Name Of Dam: WINDSOR LAKE
Location: CITY OF ROANOKE
Inventory Number: VA 77001

PHASE I INSPECTION REPORT NATIONAL DAM SAFETY PROGRAM

NOVEMBER 1980

WINDSOR DAM
ROANOKE COUNTY
9 OCTOBER 1980
PLATE II

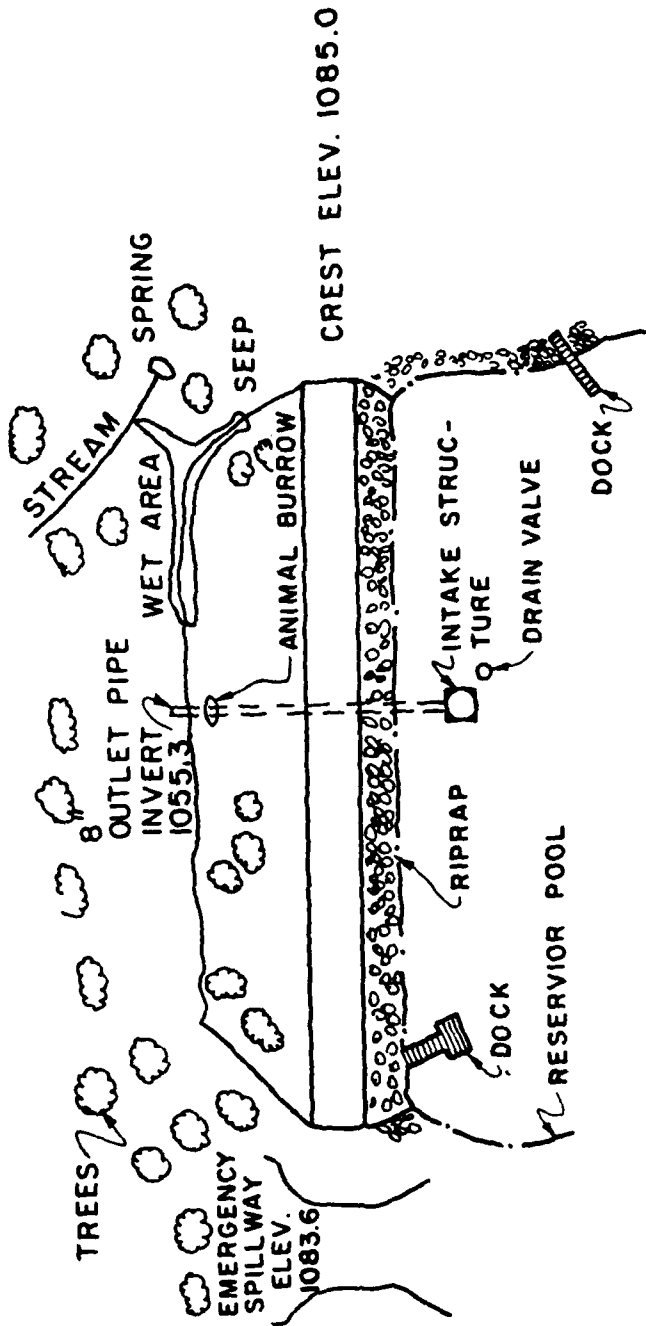
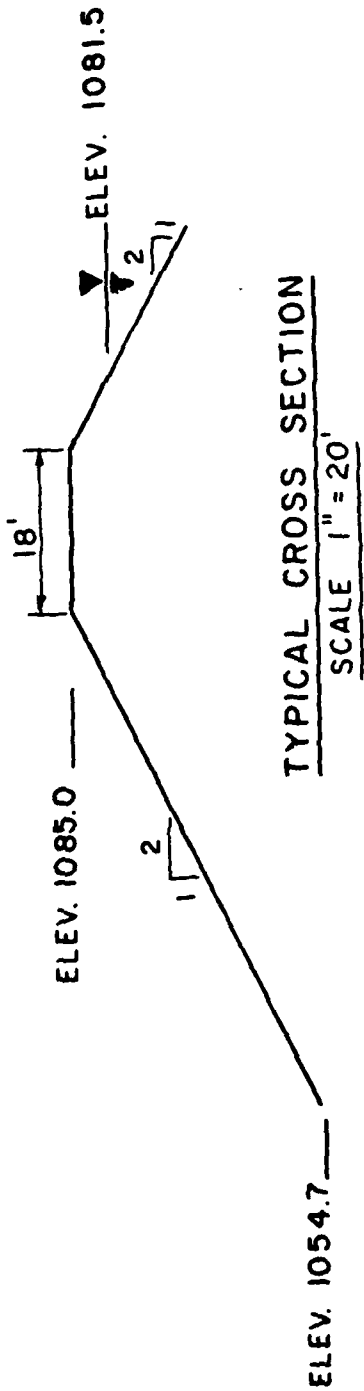
There are no signs of surface cracks, unusual movement, sloughing, misalignment, or riprap failures. However, there are several bare spots located on the crest approximately 50 feet right of the left abutment. Also, a small hole about 8 inches in diameter is located on the upstream face just above the principal spillway outlet pipe. (See Plate II, Appendix I).

A wet area is located along the downstream toe. It extends from the right abutment approximately 30 feet towards the principal spillway outlet pipe. Cattails and reeds are growing in this area. (See Plate II, Appendix I).

A seep is located on the downstream right abutment at elevation 1065.2. Its flow runs down the abutment saturating the toe, and continues downstream. The flow is clear but the rate was not measured. (See Plate II, Appendix I).

- a. The bare spots on the crest should be regraded and reseeded.
- b. The small hole above the principal spillway outlet pipe should be backfilled with compacted material and seeded.
- c. The wet area along the toe, the spring in downstream right abutment area, and flow from the principal spillway outlet pipe should be monitored for an increase in flow during periodic inspection and after higher pool levels in the reservoir. The seeps should be monitored for increased flow.
- d. The small shrubs on the face of the dam should be cut off at their roots.
